Appeal by Accrue (Forum) 1 LLP

Former B&Q Site, Great Stone Road, Stretford, M32 0YP

Reference: AC/2/C Appendices to Proof of Evidence

Dwg VN70912-D103 Highways Proposals

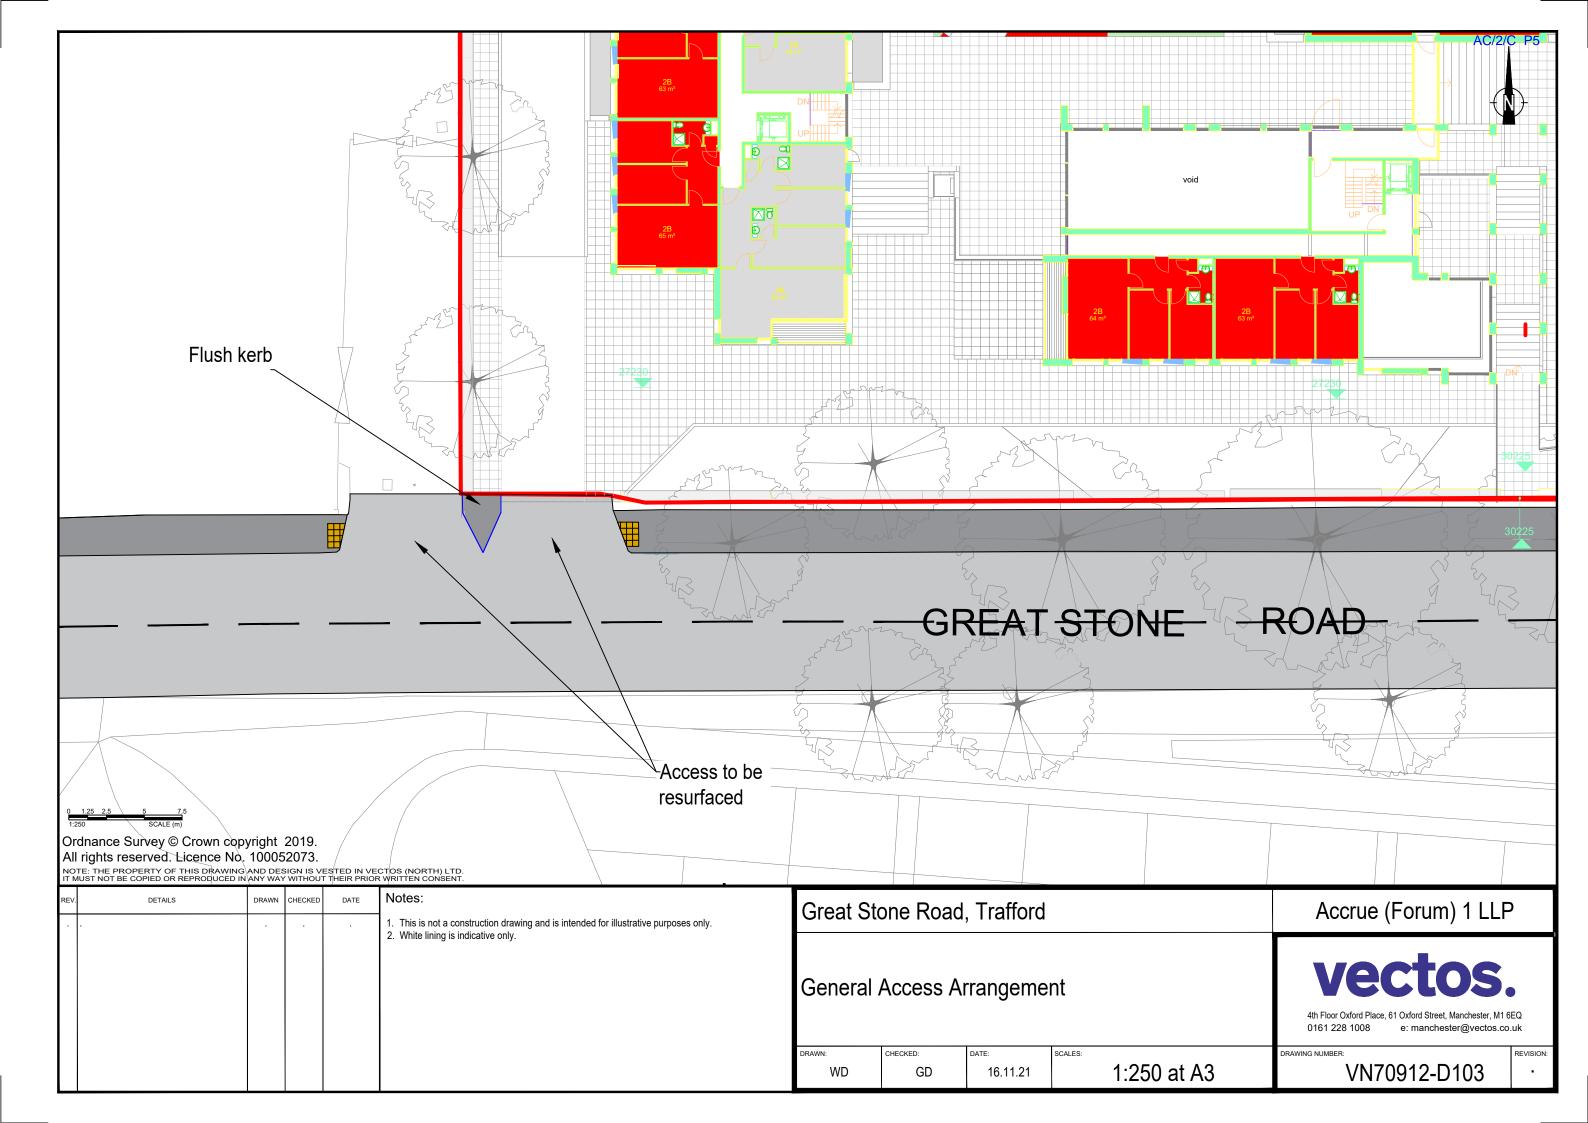
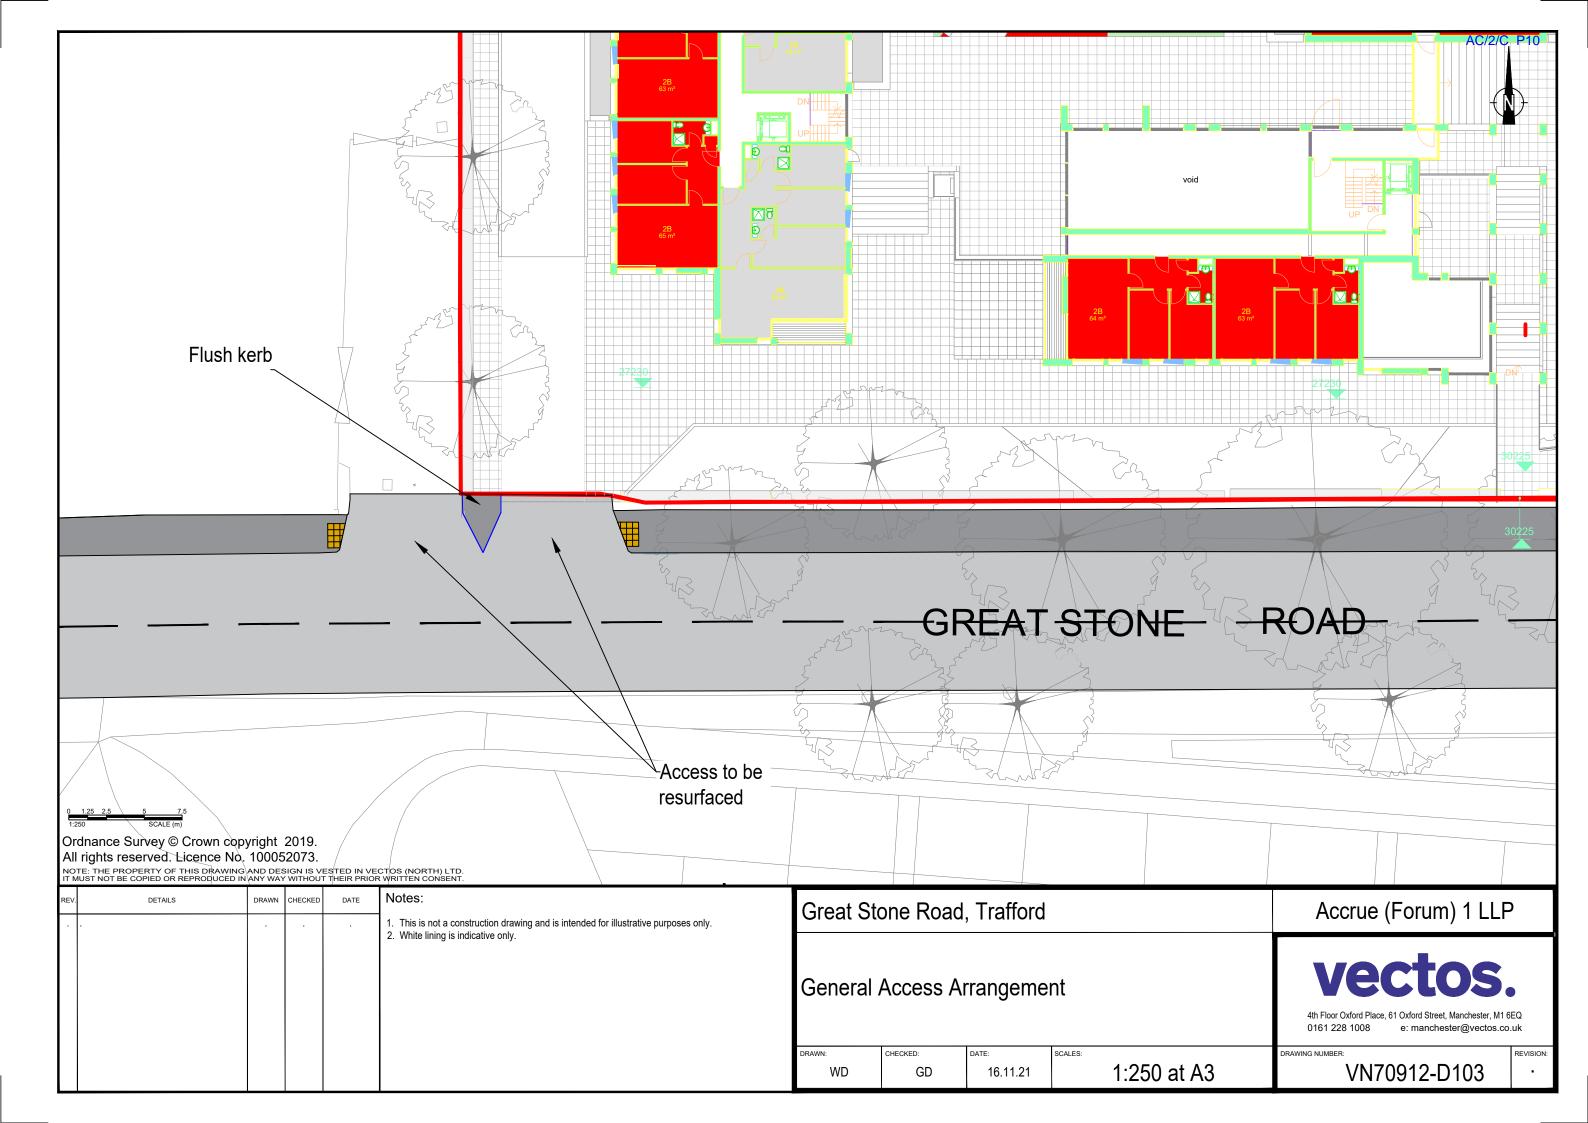
I note that, since the date of my previous letter dated 31st August 2021, the Appellant's consultants have sought to address the concerns therein by producing a new plan (Vectos drawing **VN70912-D103**).

The new plan replaces what was interpreted to be a corner radius and tactile paving in the area between the Appeal site access and LCCC's site access with a pointed flush-kerbed separation arrangement between the two access points.

This new solution does ostensibly appear to go some way towards addressing the concerns in our letter.

However, the concerns are not yet fully addressed because no swept path assessment plans have been provided of the new arrangement to demonstrate / confirm that LCCC's access won't be materially affected or prejudiced.

Similarly, no independent Stage 1 Road Safety Audit is mentioned or appears to have been undertaken, as raised in our letter.

There are works proposed on the public highway and this should be addressed to see whether a qualified and independent road safety auditor might still raise concerns about potential pedestrian and vehicular conflicts with this new arrangement.

These important items of missing information should be addressed to determine whether the revised arrangements are satisfactory from a road safety and operational perspective.

In summary, Vectos consider that further swept path assessment is not required due to the fact the 'island' feature in the central part of the double junction bellmouth arrangement on their latest drawing would be level and flush with the surrounding carriageway, and could therefore be overrun by large vehicles without impeding their movement. I agree this would be the case and that no further swept path assessment is therefore necessary.

In regard to the point about road safety audit however, Vectos have indicated that a Road Safety Audit RSA (Stage 1&2) could be provided at S278 stage, which is the post-approval, detailed design stage.

However, according to the CIHT SoRSA Road Safety Audit Guidelines 2021 (available here: https://www.ciht.org.uk/sorsa/manual-home/), Stage 1 RSA should ordinarily be provided at 'preliminary' design stage, which in planning terms equates to a point prior to determination of a planning application.

In the case of the Appeal scheme, and if allowed, the proposals would change road user behaviour because an extant DIY retail store use of the site would be replaced by a large residential redevelopment. The residential development will give rise to a different dynamic and profile of pedestrian users in the area than if the DIY store re-opened, where customers purchasing often bulky goods would be expected to arrive by car in most instances.

A residential use will likely generate materially more pedestrian trips across the junction bellmouth than a DIY store, and furthermore, those increased numbers of pedestrians could be composed of vulnerable users (i.e. residents who are elderly, disabled, children, parents with pushchairs etc).

If it is the intention to introduce a new flush 'island' in the centre of the double junction bellmouth, which some of these pedestrians could perceive as a safe haven to stand within when crossing the wide double junction bellmouth, but then simultaneously to propose that this island has been specifically designed to be overrun by large vehicles, then it is not unreasonable to suppose that an independent and qualified road safety auditor might find fault with this arrangement, and recommend some significant changes. Such changes might hypothetically not be within the Appellant's control to deliver.

It therefore follows logically that it would be prudent, in view of the SoRSA Guidelines, to carry out a Stage 1 Road Safety Audit prior to any Appeal determination, so as to give comfort to the Inspector and other stakeholders that the access will operate safely and satisfactorily, and that a viable solution is in fact achievable, before proceeding to the S278 detailed design stage when a separate Stage 2 RSA would normally be carried out.

Thank you for your response dated 30th November to our plan **VN70912-D103** of the proposed highway works at to access the development off Great Stone Road. Your assumption is correct in that the proposal is for flush surface treatment and that this does not affect the movement of vehicles in and out of either access. In practice the works are simply surface treatment to the pavement. As there is no physical change to the access arrangements other that the surfacing there is no change to the vehicle movements in and out of the LCCC access. Therefore I consider that there is no need to track the swept path of surface vehicles accessing nor a need to undertake a Road Safety Audit at this stage.

The Local Authority has not presented any objection to the scheme on highways grounds. The resurfacing works will be subject to a Section S278 agreement and if required by the local authority then a Road Safety Audit (Stage 1&2) could be provided to demonstrate that the works are safe and are appropriate to the council's requirements.

Following your letter dated 10th December, I understand that you do not require swept path tracking of vehicles and accept that there is no restriction of LCCC vehicles in or out of Emirates Old Trafford and this is helpful in keeping the Inquiry focussed on the key issues of concern.

I can see that you have asked for a Stage 1 Road Safety Audit to be conducted on the proposed design. As a starting point I note that the local Authority has not objected to the access design. Secondly, I have not seen any evidence proposing that that the existing layout is unsafe. Furthermore I have not seen evidence that by changing the land use from DIY Store to residential land use would, by generating more pedestrian movements, create a significant hazard for pedestrians.

The concern presented in your letter is whether a flush kerb detail could give the impression to pedestrians have a safe haven and that in turn could potentially give rise to a safety issue. You then argue that this may then be picked up in a Road Safety Audit process and an adverse audit response would somehow prevent an access from being achievable. This hypothetical scenario is not a cogent argument. While I consider that the flush kerb detail would not be a hazard, there is scope to simply remove it from the design if it was picked up as an issue in the Road Safety Audit. We would then have a layout similar to the existing situation (with the benefit of tactile paving at either end).

The request for a Road Safety Audit is therefore in my view a distraction from the focus of the Inquiry as highway design would be subject to the approval of the Local Highway Authority through the Section 278 process and be subject to a Road Safety Audit in any event.
